TSRC PART 2
A.0 - INTERPRETATION

TSRC
PART 2 - CLARIFICATION QUESTION
A.1.1 - Traffic

TSRC
PART 2 - CLARIFICATION QUESTION
A.1.2 - Road Geometry & Road Safety

# Technical State Clarification Questions – NEXUS (03.02.02.19)

TSRC
PART 2 - CLARIFICATION QUESTION
A.1.1 - Traffic
Attachment for T116

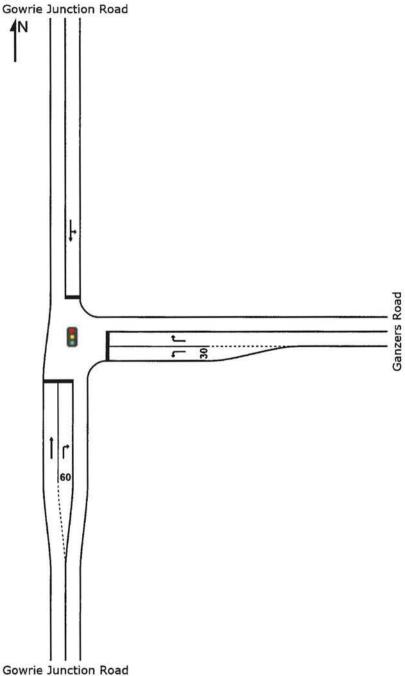
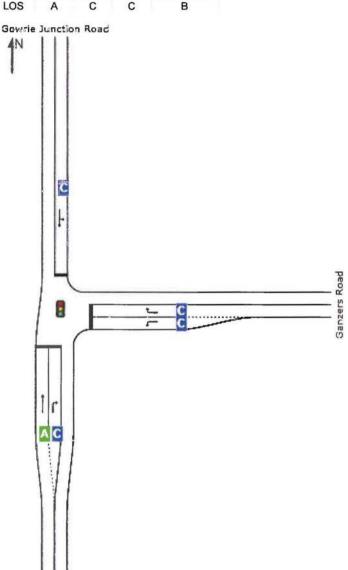
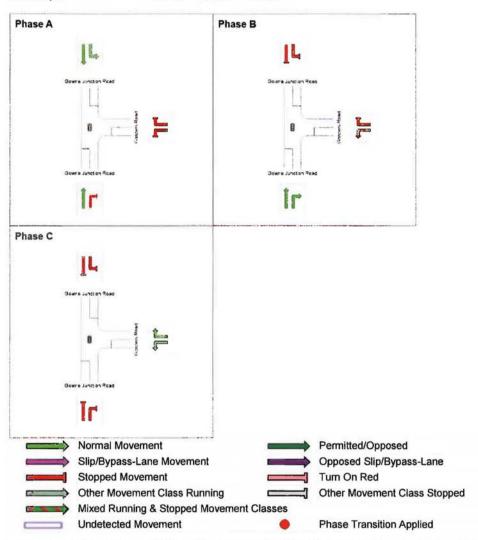
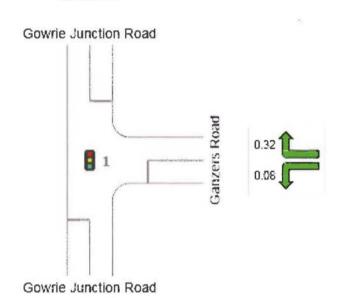
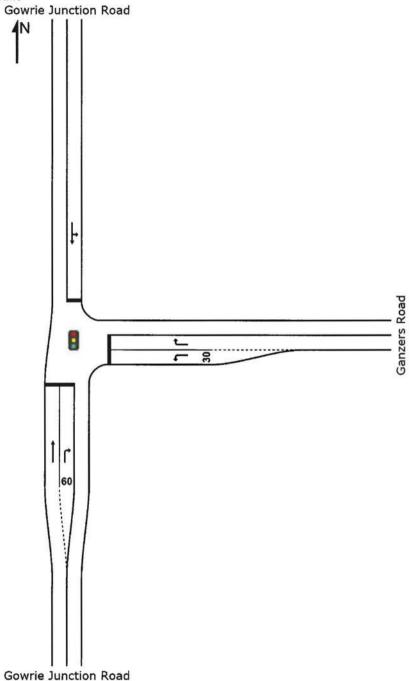
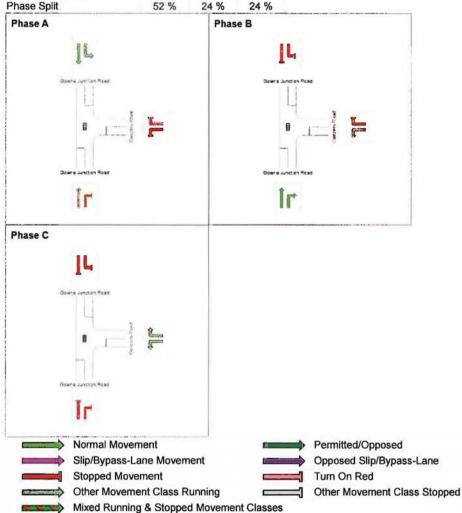
Question ID	Report Reference	Performance Specification Reference	Question	Proponent Response
T116	A1.1		Can the Proponent please confirm they have assessed all the Toowoomba Regional Council (TRC) controlled intersections for level of service (LoS C) in accordance with the Performance Specification, Exhibit A, Section 3b(viii).	The Toowoomba Regional Council (TRC) controlled intersections have been analysed based on various assumptions to generate traffic numbers as traffic data wasn't made available during the RFP phase for all the intersections.  As reported in the traffic element report, A.1, section 5.3.1 the LoS at the Gowrie Junction Road and Ganzer Road intersection is predicted to be LoS D if it is un-signalised. To achieve a LoS C or better signals need to be provided.  A sketch showing the new configuration of the intersection is attached as Appendix T116a along with the corresponding traffic reports (Appendix T116b).  Nexus confirms that there is no impact on either D&C or Operations and Maintenance costs.

TSRC
PART 2 - CLARIFICATION QUESTION
A.1.2 - Road Geometry & Road Safety
Attachment for T81

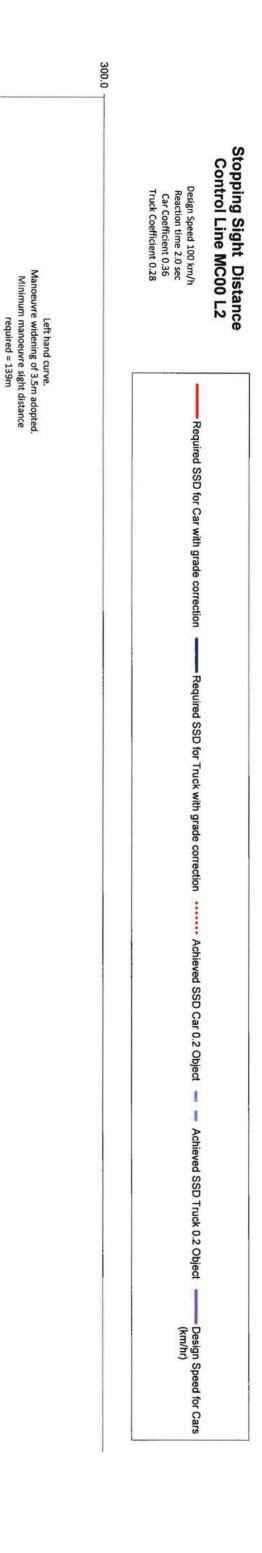
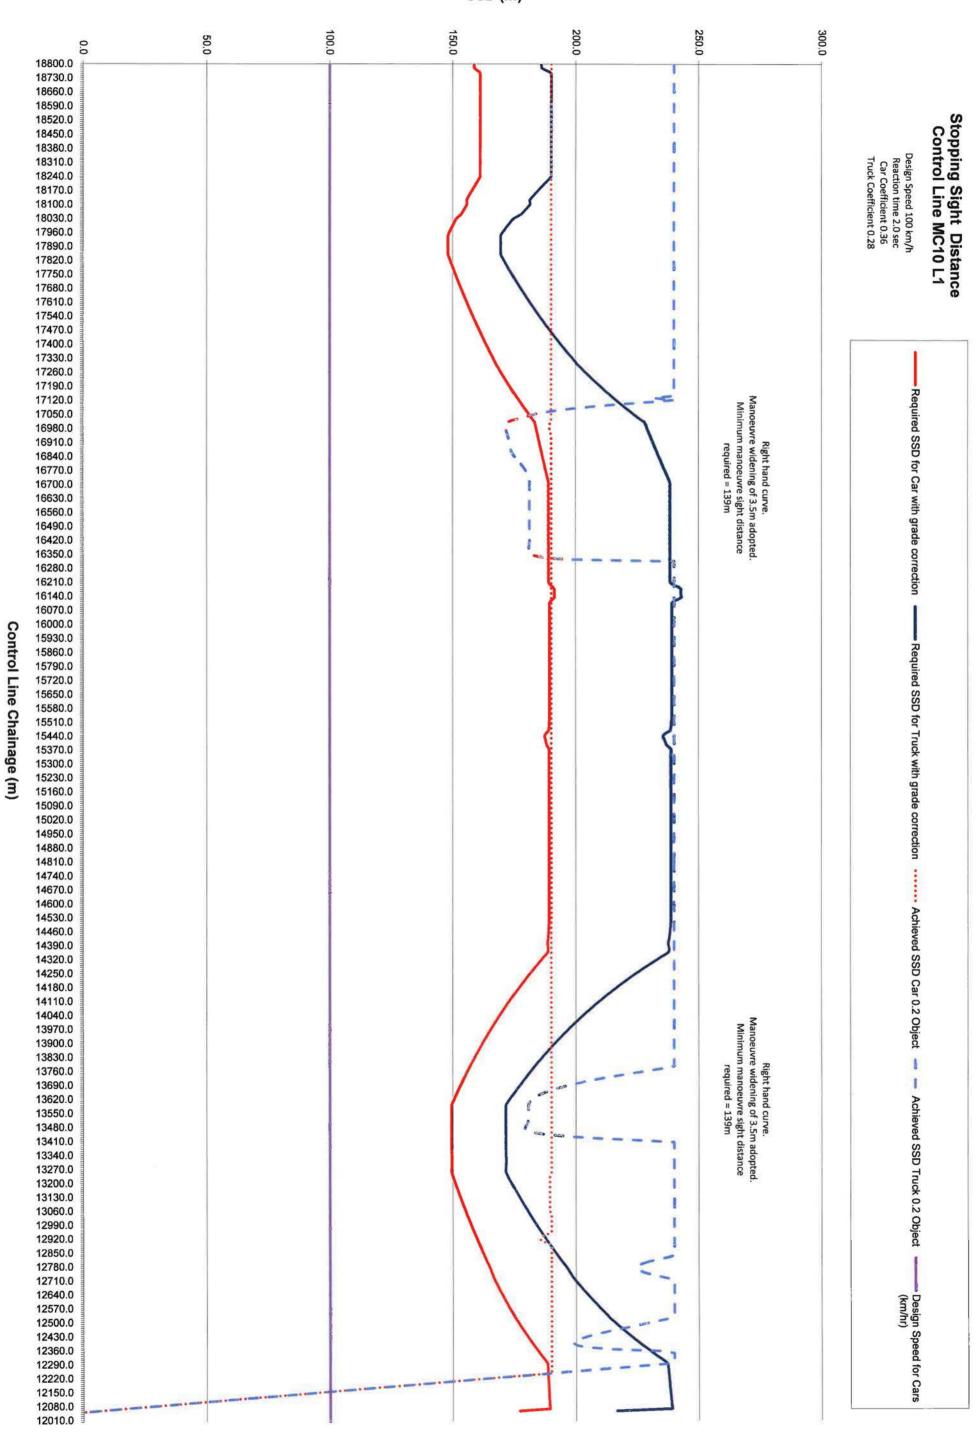
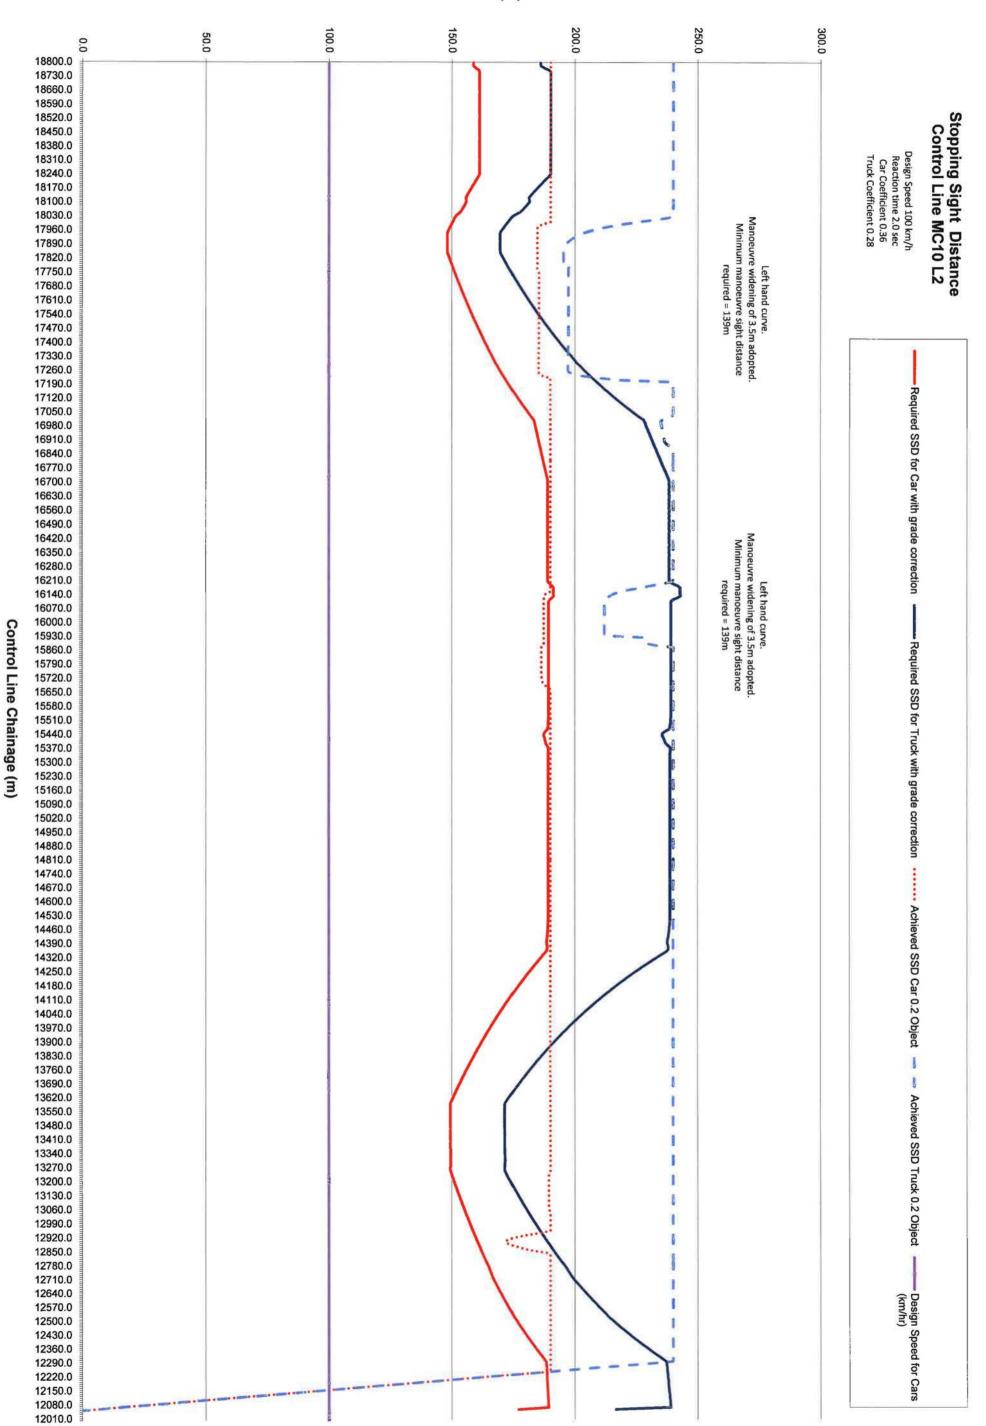
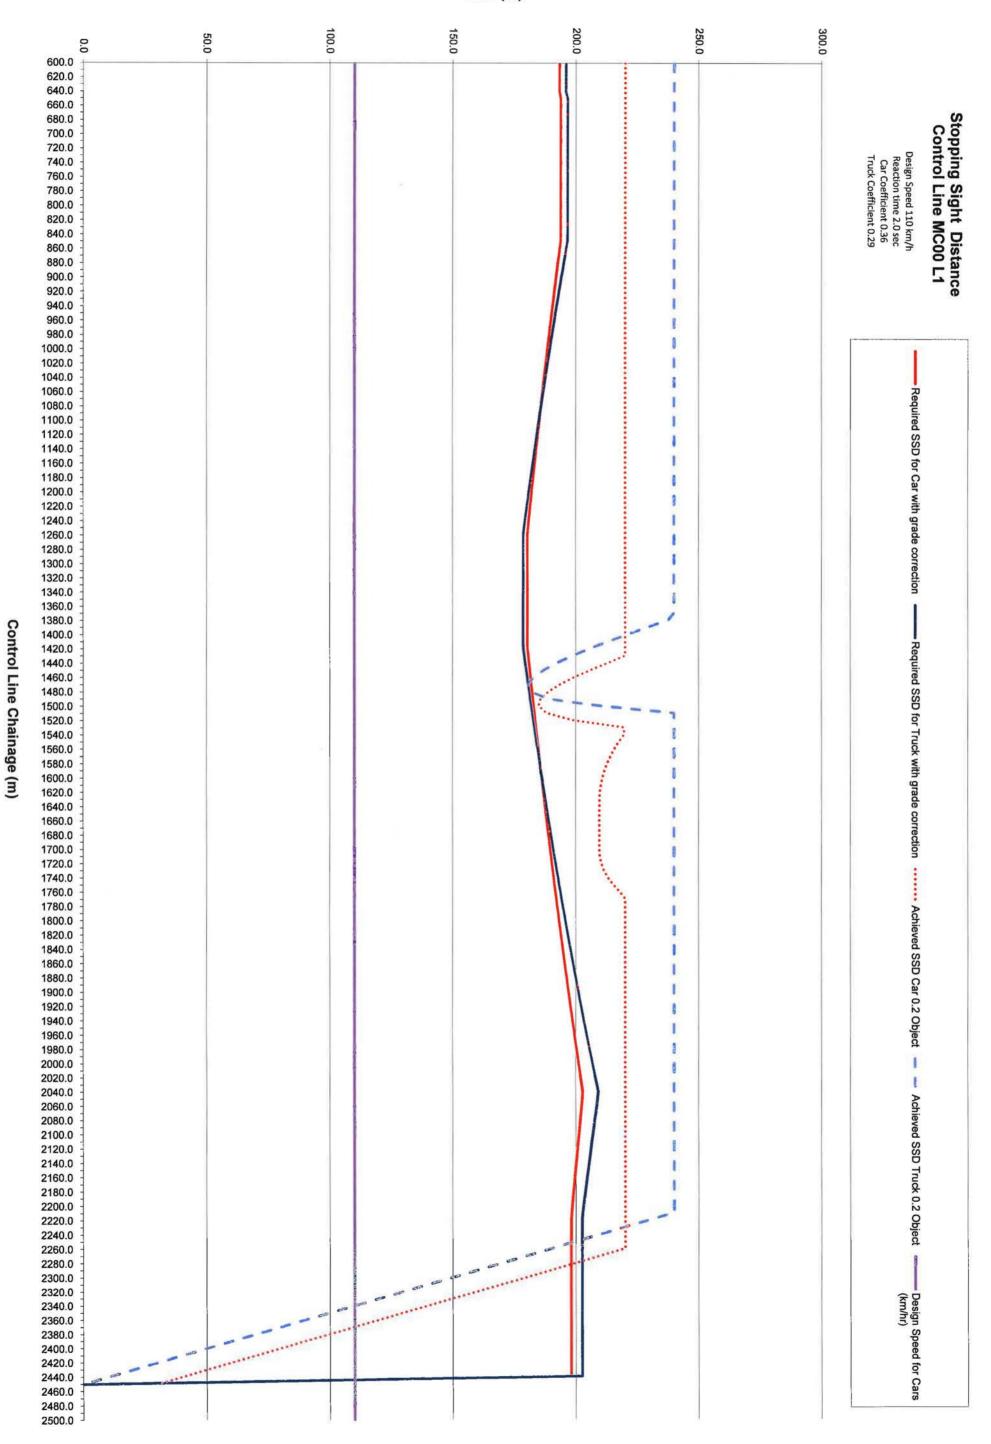
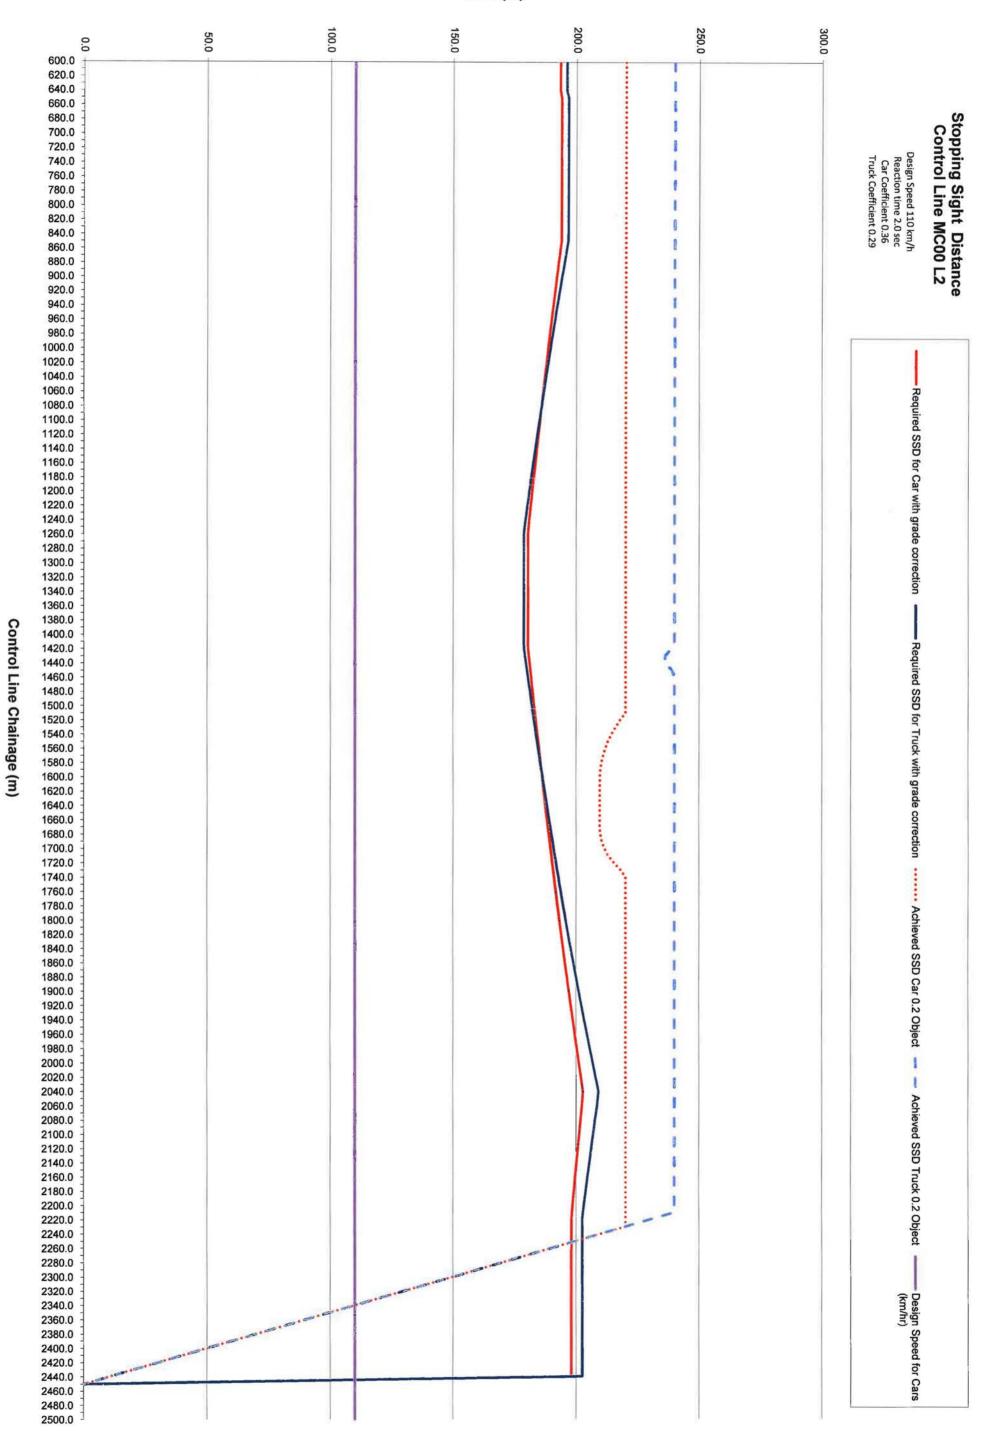
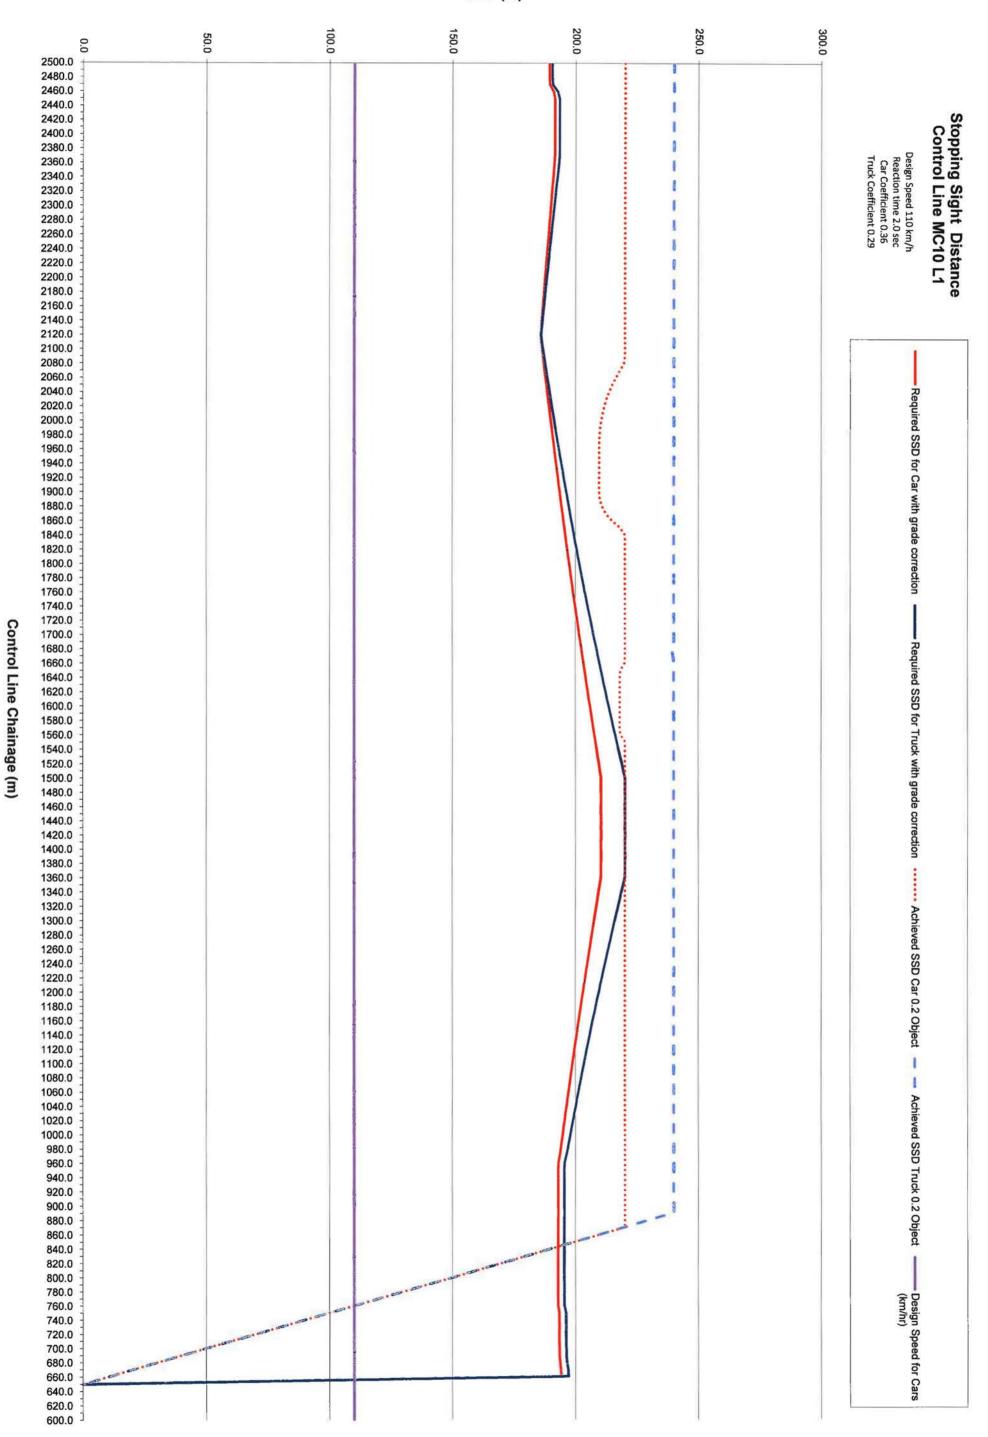
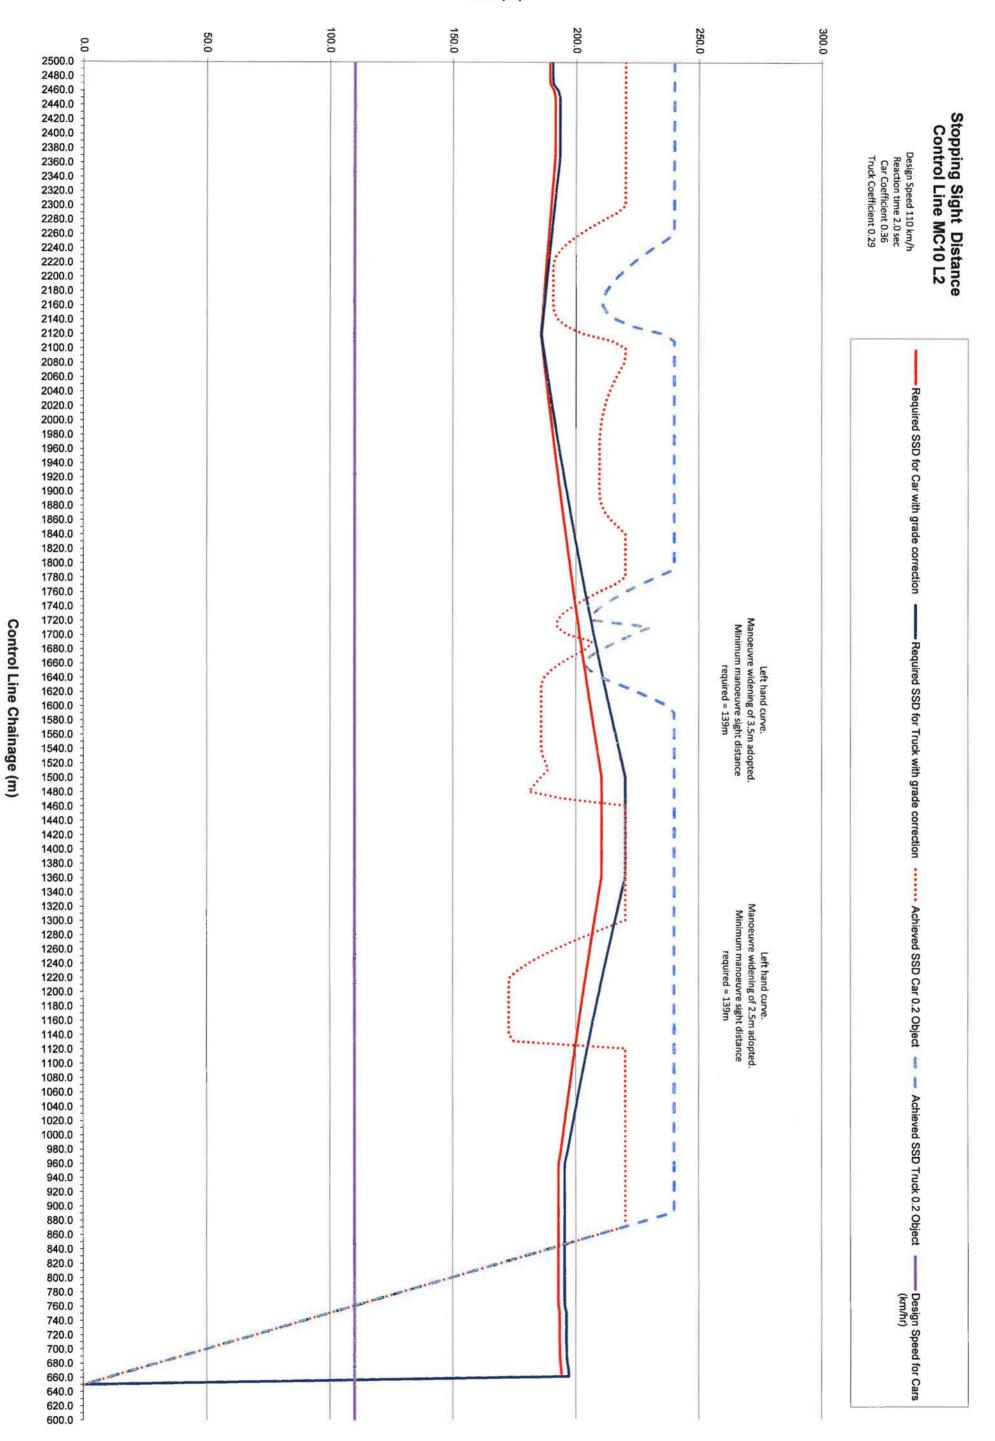
T81	A1.2	Boundary Street in your PAM design in accordance with AustRoads Table 7.1.	AUSTROADS Part 4c: Interchange, Table 7.1 requires that 215m of sight is provided to the exit nose for a design speed of 110kph.  We confirm that 215m sight is provided to the westbound exit nose for the Pre Agreed Modification at Boundary Street.  Please see Appendix T81		
Т82	A1.2	The State is seeking further information regarding your Alternative Option and request that you provide the horizontal and vertical SSD checks and graphs for your Alternative option alignment.  This information should be sufficiently detailed for the State to consider the compliance of your Alternative Option.	Please find attached the horizontal and vertical SSD checks and graphs for Nexus' Alternative Option alignment in Appendix T82a, T82b, T82c and T82d.		
Т94	A1.2	(시간) : [ [ [ [ [ [ [ [ [ [ [ [ [ [ [ [ [ [			
Т97	A1.2	Interchange in accordance with the requirement of RPDM Chapter 15, Figure 15.6.  Please confirm your compliance with these requirements, and what impact, if any, this has to your Proposal including program, cost or other related items.	We assess that the run out area to the West bound entry ramp requires a minor increase in the pavement area. At the East bound entry ramp, the run out area requirement would involve realigning the ramp to reduce its overall length resulting in a corresponding minor downward adjustment in the pavement area. The structure over the existing railway would require some tapered shoulder widening (0.62-0.00m) with a minor change to the area of structure (ca. 9 sqm).  Nexus confirms it will comply with these requirements with no impact on its Proposal, including program or submitted price.
